UNITED STATES OF AMERICA
NUCLEAR REGULATORY COMMISSION

Docket No. 50-361

Amendment Application
No. 116

DESCRIPTION AND SAFETY ANALYSIS
OF PROPOSED CHANGE NPF-10/15-407

SKETCH B

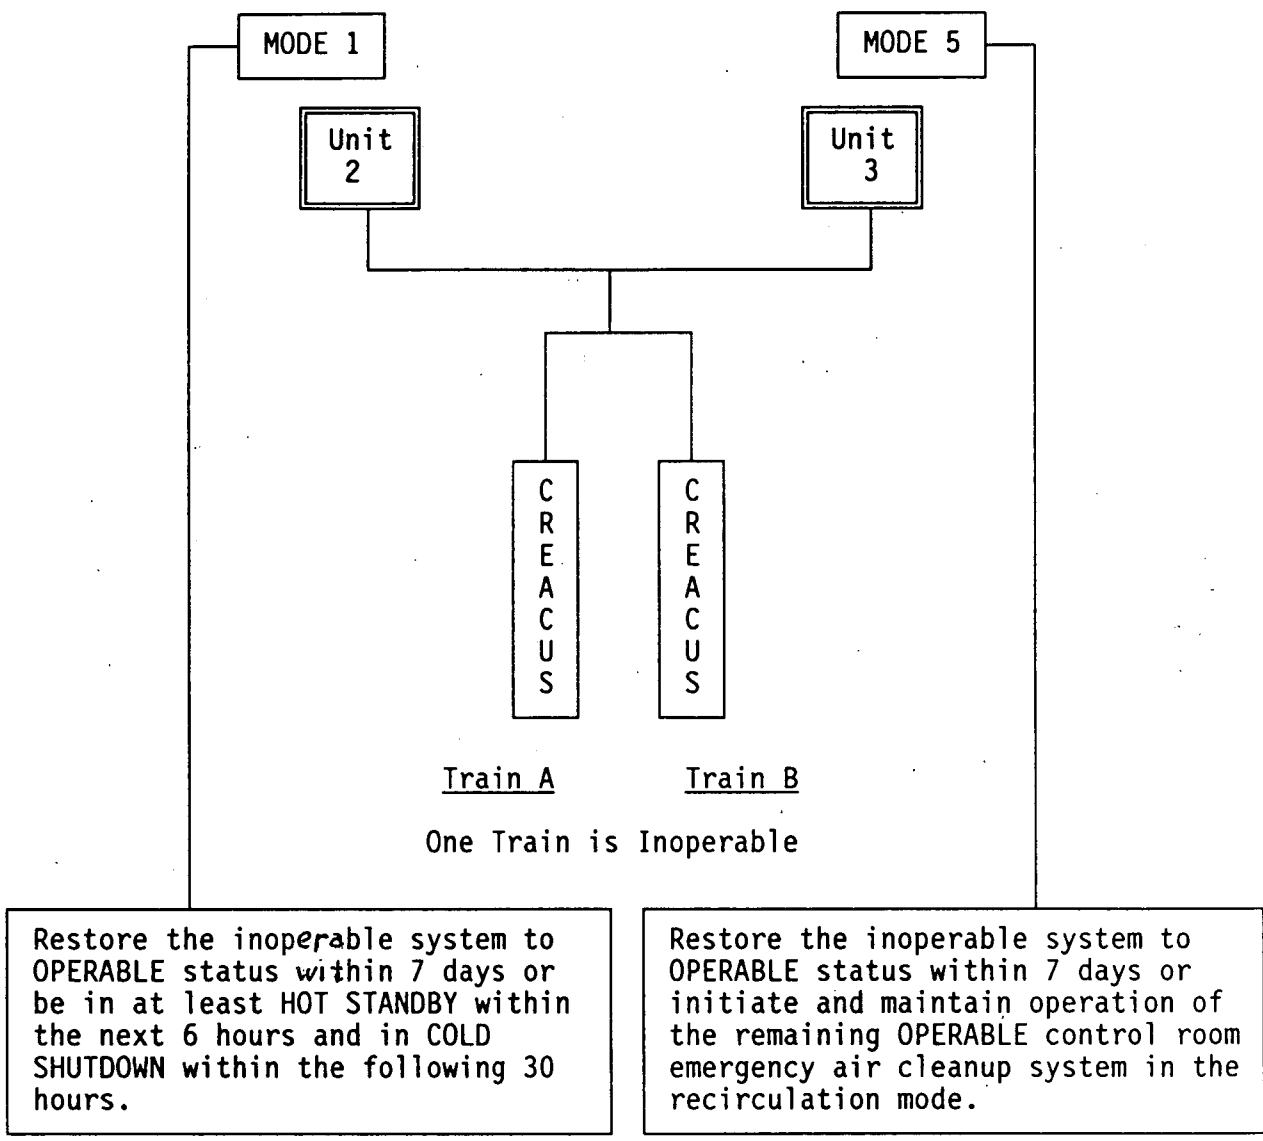
1. The NOTE " Each Unit shall enter applicable ACTIONS separately" was inserted before the ACTION statement.

The Technical Specifications do not address the operational situation when the Units are in different operational MODES. Because of different REQUIRED ACTIONS some confusion could take place. For example, if Unit 2 is in MODE 1 and Unit 3 is in MODE 5, the Required Actions for each Unit are not only different but conflicting (See Sketch B.). Without this NOTE it may not be clear what ACTION should be taken.

The proposed NOTE "Each Unit shall enter applicable ACTIONS separately" clarifies an operational situation when both Units are in different operational MODES.
